March 11, 2021

RE: **PETITION NO. 1425** – Gaylord Mountain Solar Project 2019, LLC petition for a declaratory ruling, pursuant to Connecticut General Statutes §4-176 and §16-50k, for the proposed construction, maintenance and operation of a 1.9-megawatt AC solar photovoltaic electric generating facility located at 360 Gaylord Mountain Road in Hamden, Connecticut, and associated electrical interconnection.

## **DRAFT Findings of Fact**

### Figure 3. Proposed Site Layout and Location of Wetlands

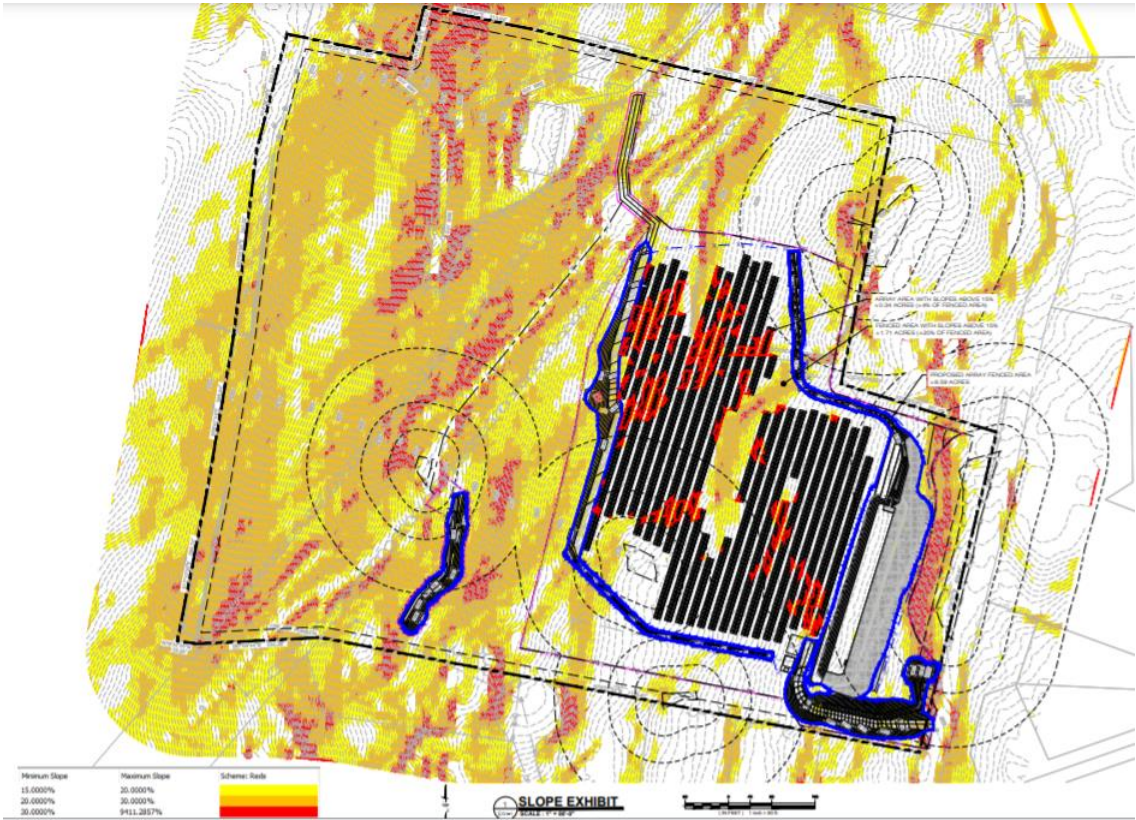
182. A total of five wetlands, collectively comprising approximately 0.44 acre, are identified within the site property. Wetlands 1 and 4 are scrub-shrub and emergent vegetated wetlands; Wetland 2 is transitional scrub/shrub, cleared/maintained emergent wetland that has been disturbed, Wetland 3 abuts Gaylord Mountain Road with varying degrees of historic impacts including vegetation management and accumulation of debris, and Wetland 5 is forested (refer to Figure 3). (GMS 1, Exhibit H, pp. 17-18; GMS 2, response 47)

**Figure 4. Proposed site layout of panels on slopes greater than 15/20/30 percent**

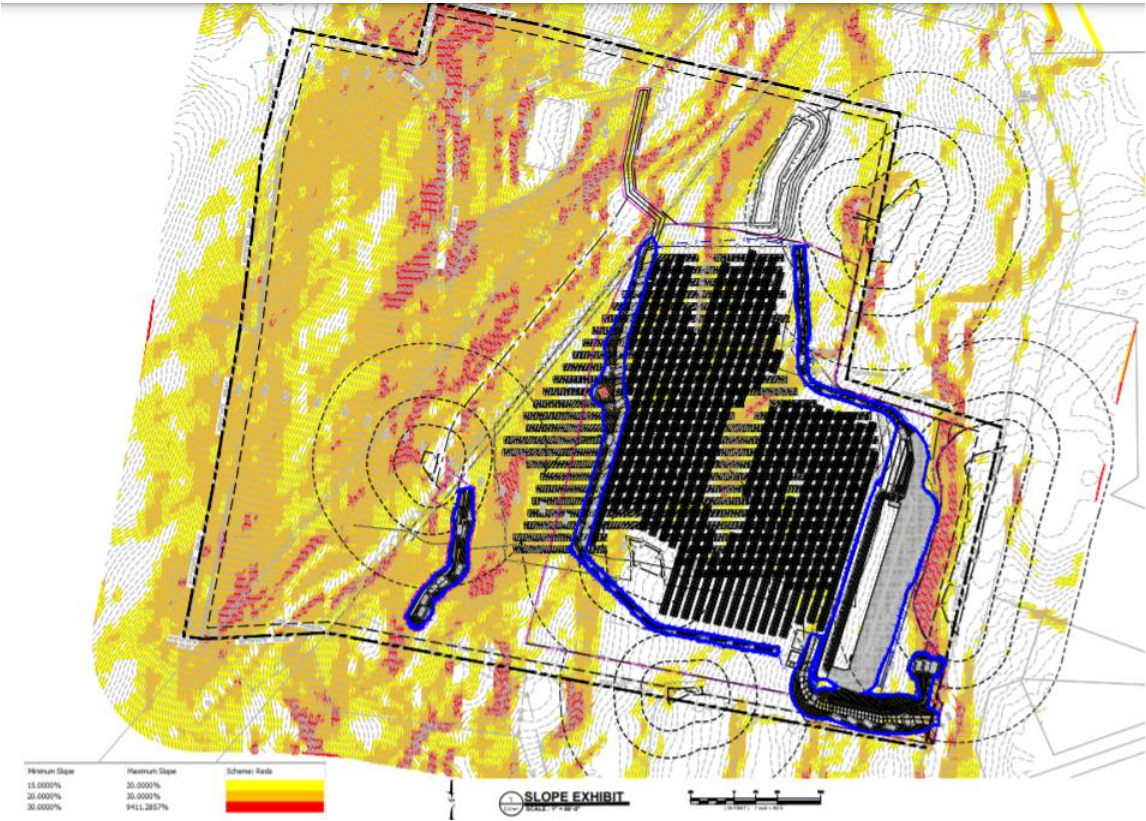
77. Approximately 0.34 acres of the 8.6 acre solar field area have slopes greater than 15 percent (refer to Figure 4). (GMS 11)
78. The final design of the racking system has not been determined. Racking would consist of a combination of driven posts, drilled piers and/or ground screws, to a maximum depth of approximately 10 feet. (GMS 2, response 44)
